ADW22400 Cap Shim

3/5/2020

Executive Summary:

AlGe Seal with Cap Shim

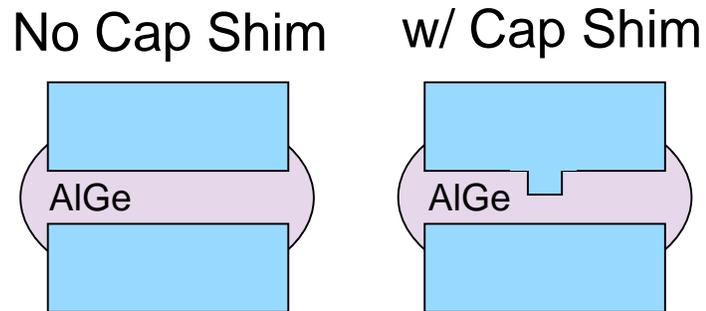
- ▶ ADW22400 AlGe bonded Z-axis sensor experiences stiction after:
 - High moisture stress (85C/85%, Autoclave, THB, UTHB)
 - ATE
- ▶ ADW22400 implemented Cap Shim on the AlGe seal
 - Cap Shim incorporates a Si “bump” patterned on the bottom of the cap seal ring
 - AW22400 with Cap Shim passed high moisture stresses (AEC-Q100) with no stiction failures
